ADDENDUM NO.: THREE

PROJECT TITLE: ADMISSIONS & VISITORS CENTER
UNC CHARLOTTE
SCO ID# 15-12632-02A
WTS Project No. 1604

WRITTEN BY: Jana Hartenstine, AIA, LEED AP BD+C, CDT

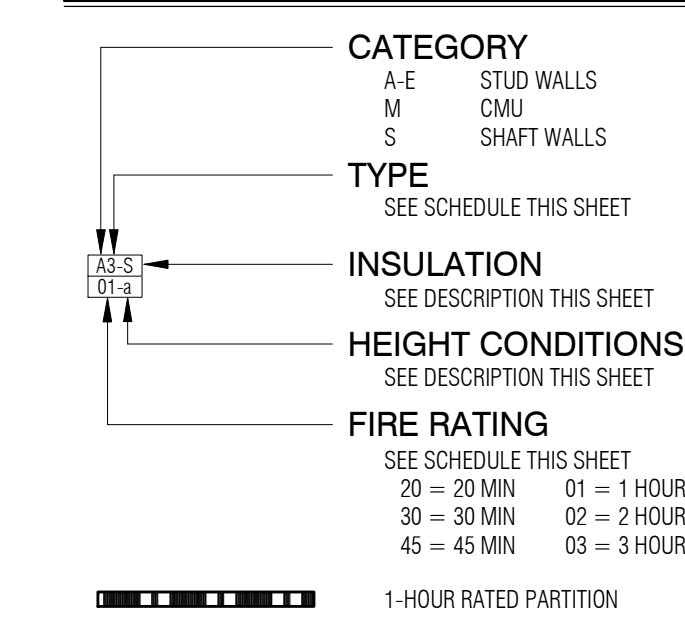
WWF at a position 1" below top of slab. "Hooking and lifting" WWF at time of concrete placement is NOT ACCEPTABLE.
66	Where is the material info for VWC-02 called out on drawing A8.0 for 116 Meeting? There is a VWC-01 pattern listed but, I don't see VWC-02	The only VWC is in the 2 interview rooms. There is no VWC-02. Walls located in 116 are to be painted, egg shell finish. Color, TBD.
67	Fire dampers are shown for alternate #5 up-fit of the auditorium, they are not shown for the base bid, are fire dampers to be included in the base bid?	Provide fire dampers in the base bid.
68	Should alternate No. 06 on list of alternates read "as indicated on AA6.01 Add Alternate #6, #8, and #9?	Yes. It should read #6, #8 and #9.
69	On drawing A1.2C 2nd floor plan at 2nd floor stairs detail A3/A6.2 is calling for wall type B6-S01-a however on drawing A0.3 partition type schedule there is no such wall type. What wall type should be used in this location?	The "B" partition type has two layers of gyp board on one side and one on the other. We have added it to the partition sheet A0.3.

A3
SECTION DETAIL
1 1/2" = 1'-0"

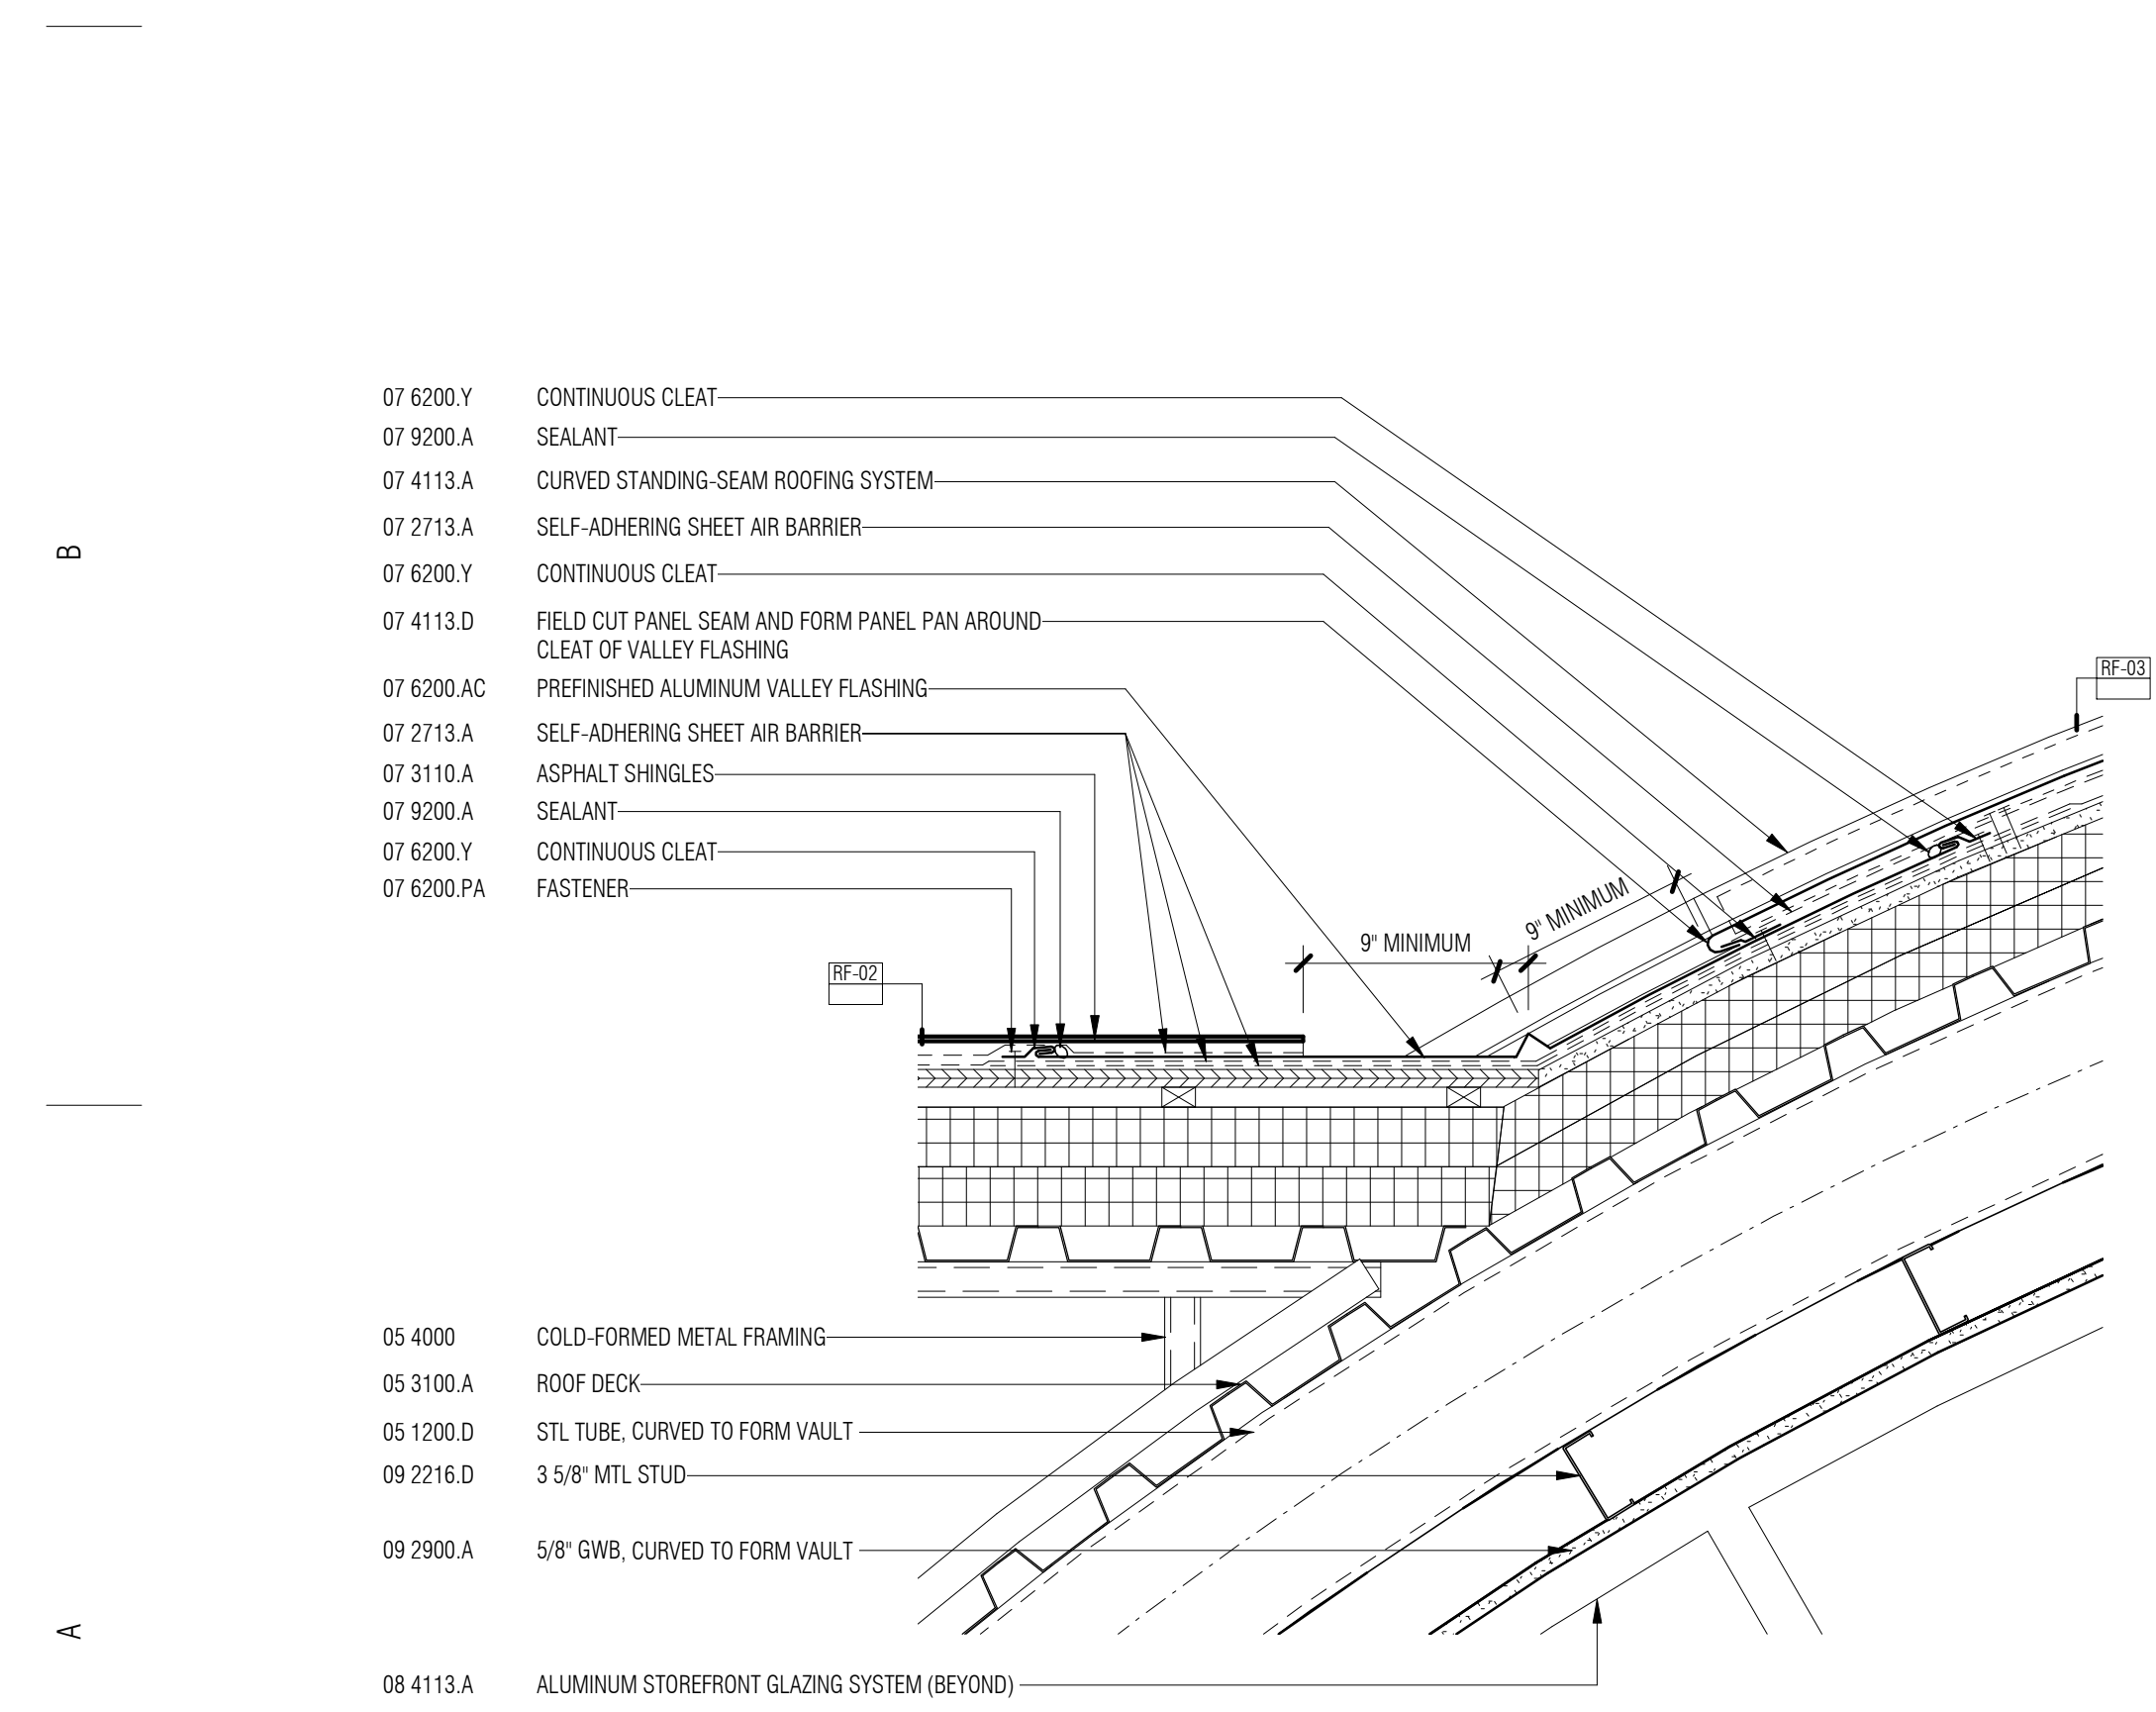
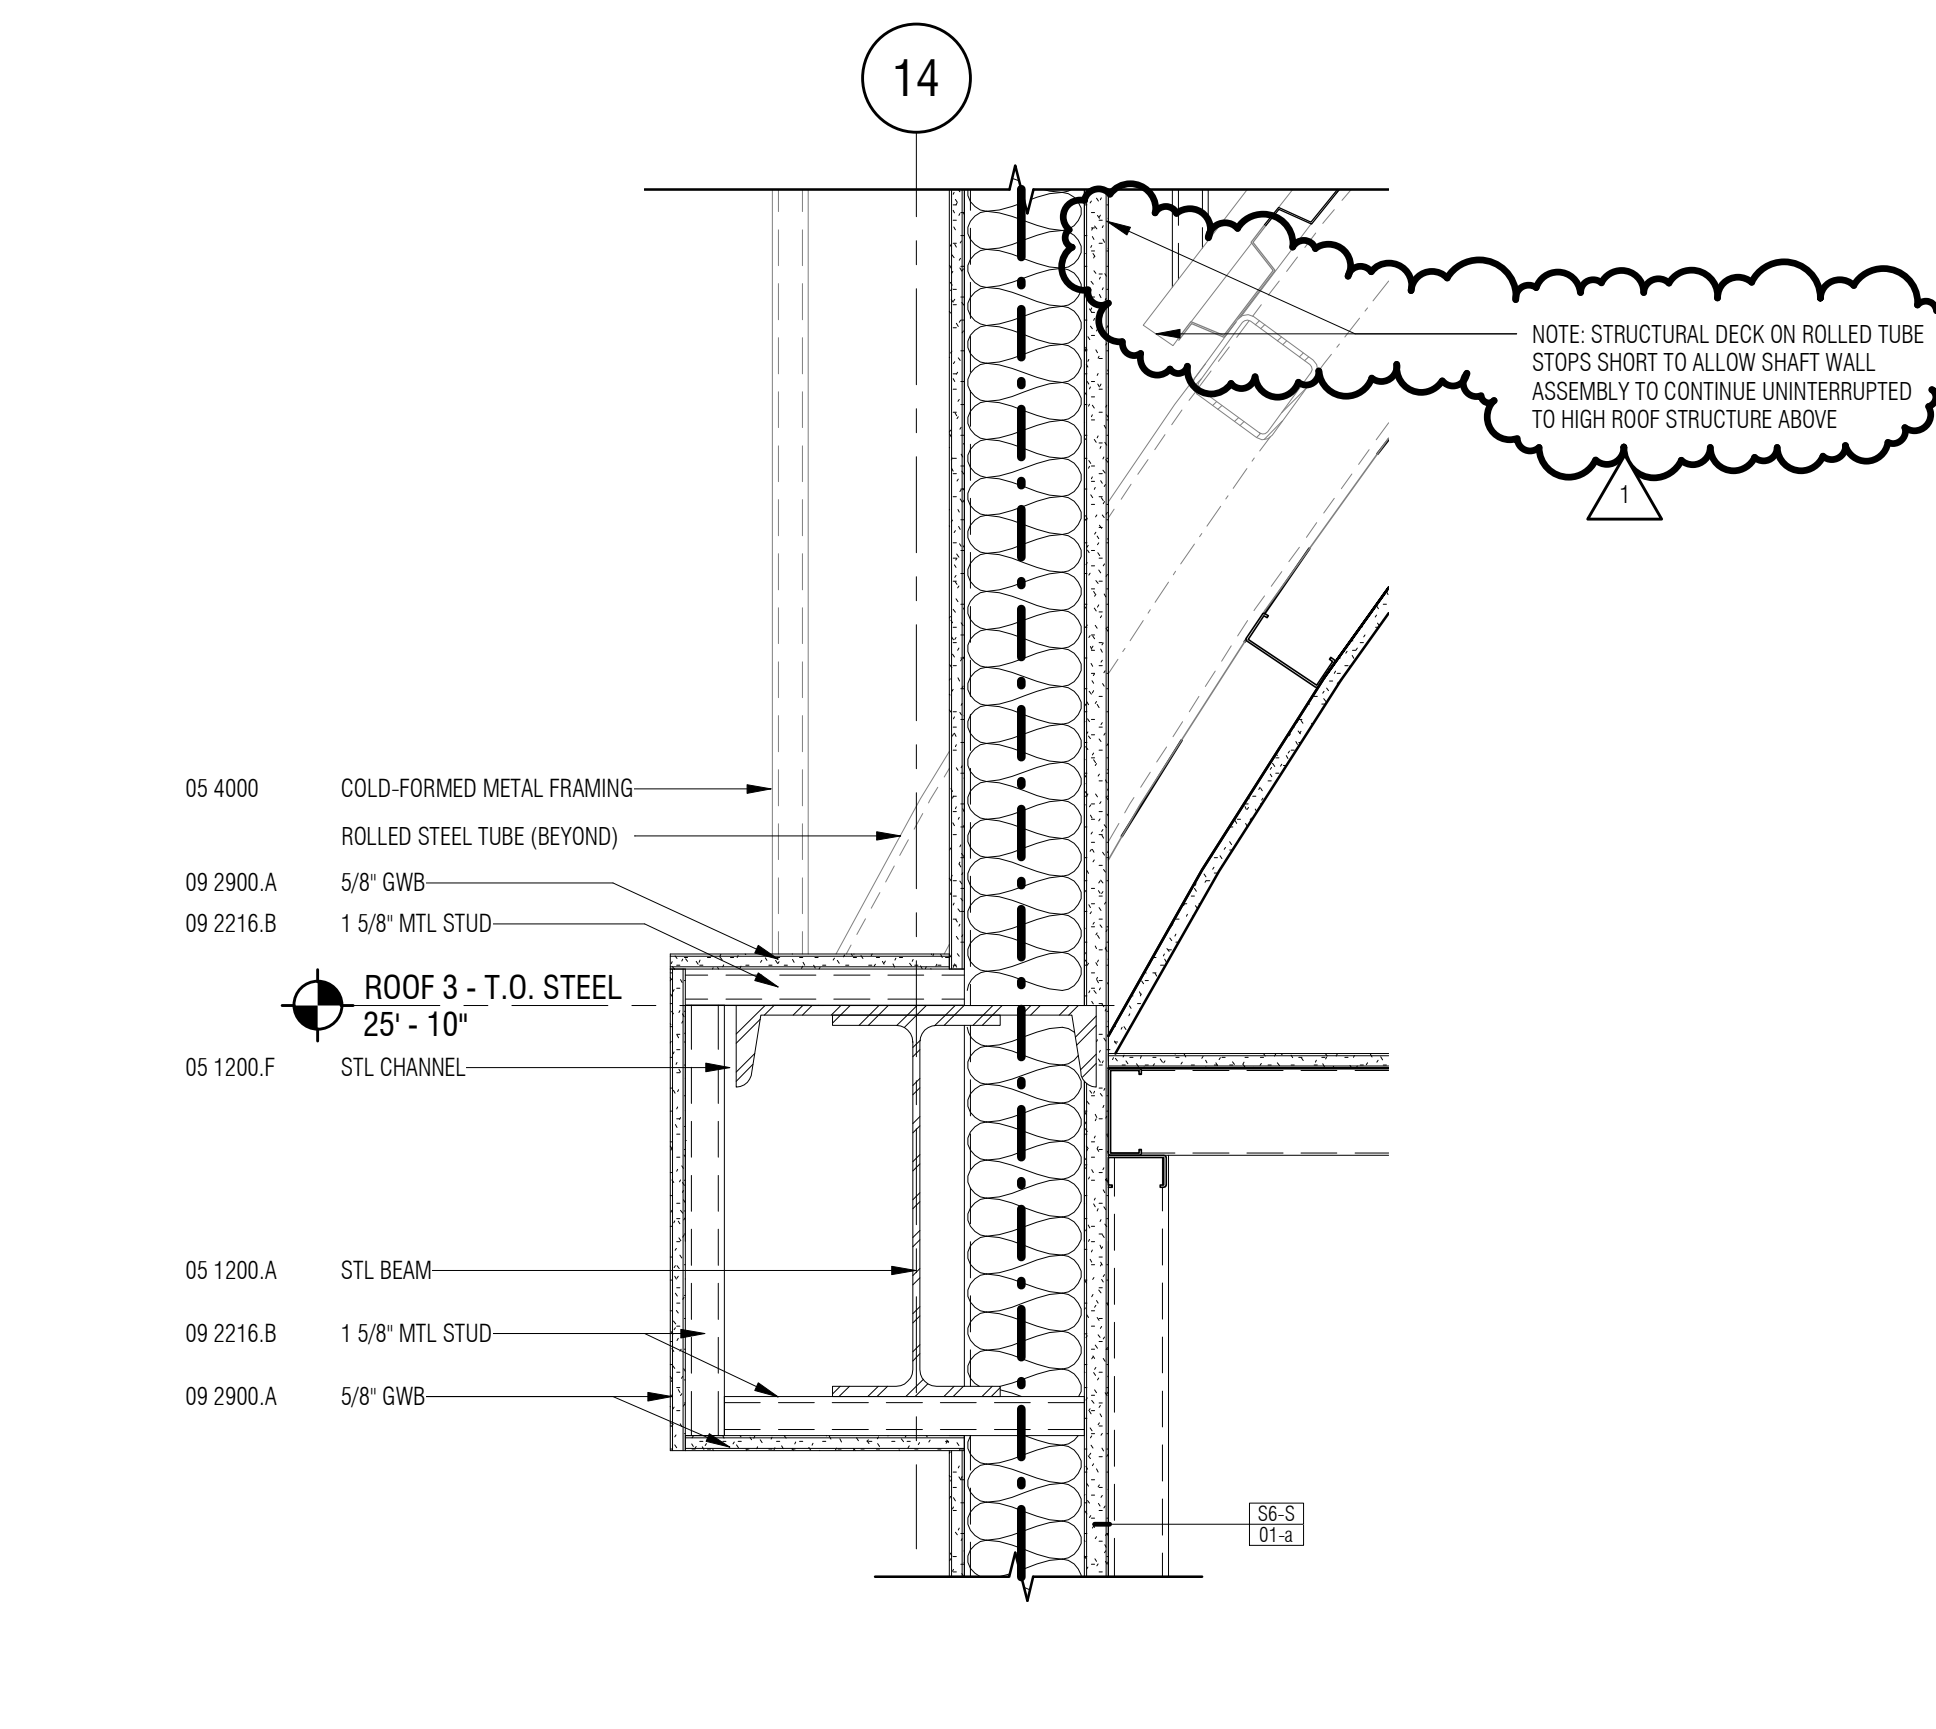
77	SECTIONS A1&A3 ON A5.2 SHOWS AN ANGLE UNDER THE BRICK, WHAT SIZE IS THE ANGLE AND HOW WILL IT ATTACH? IS IT TO BE GALVANIZED?	Provide a galvanized angle bearing on side brick min 4" . Size as an L 3x2x3/8" or to match

ACCESS CONTROL GENERAL NOTES:

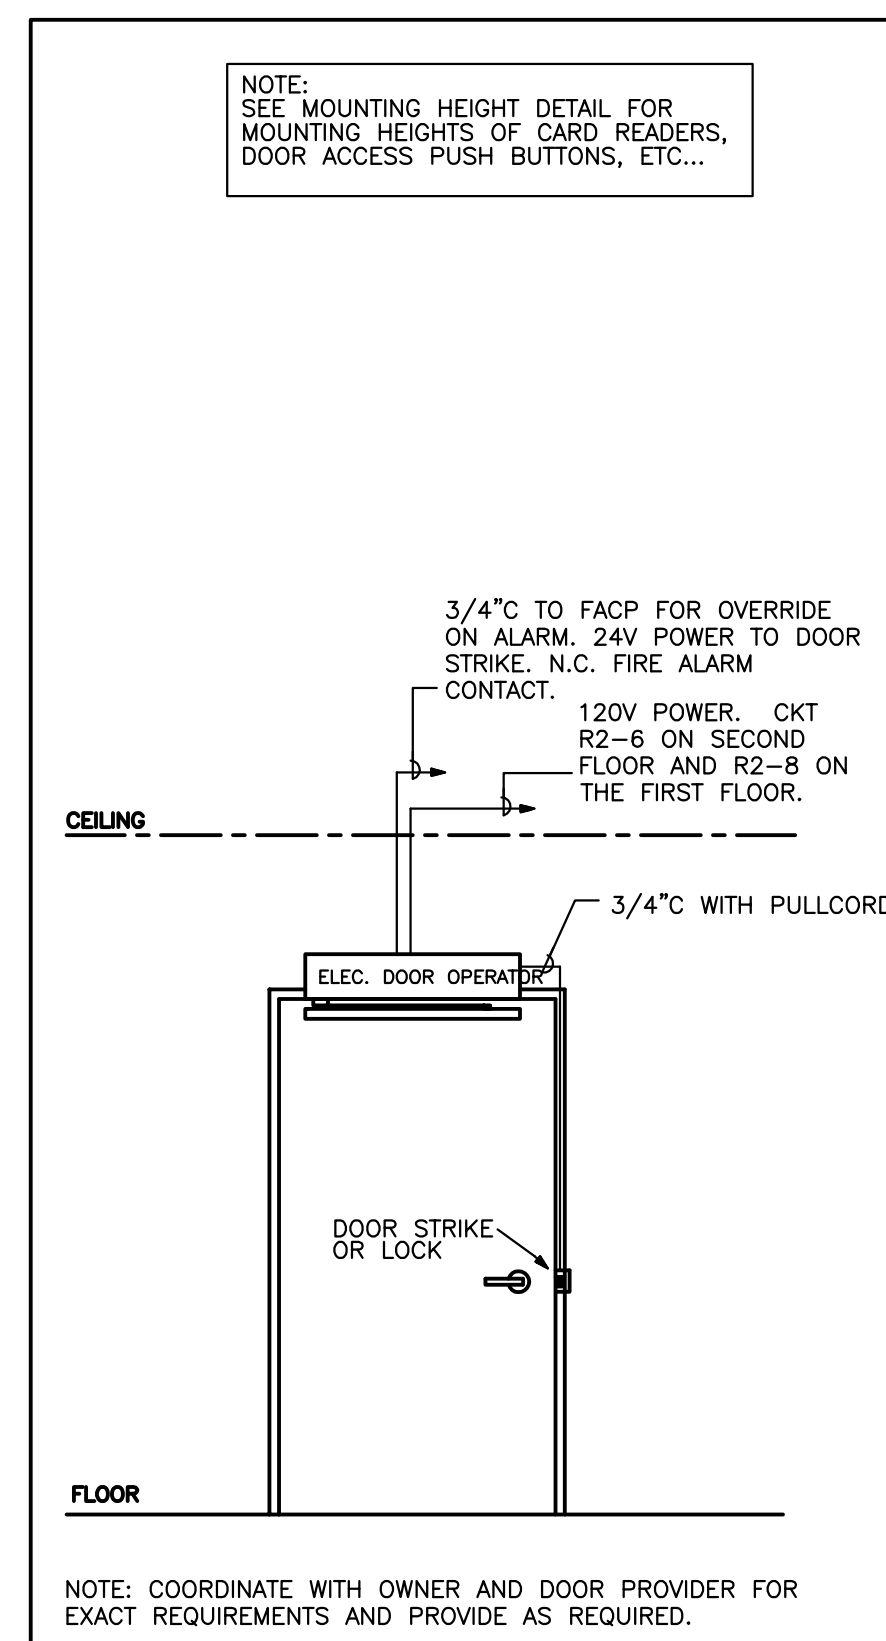
63	<p>E5.6 Access control general note 3 states for the E.C. to contact the owner's security E.C. to obtain pricing. Please provide contact information for this contractor.</p>	<p>Open Options by Brady Services. The contact for construction is Ryan Hughes 980-266-9279.</p>
64	<p>E5.6 Access control general note 1 states for the E.C. to provide and install a complete working system and then in the next sentence it indicates the door access controls are by others. Please clarify the extent of the access control scope of work that should be included with our bid.</p>	<p>The E.C. should be working with the security integrator. The E.C. is responsible for providing the access control system and a complete integration of the other items that are by others. The items that are by others include the access control components such as card readers, push buttons, electric strikes, pedestals, etc..</p>
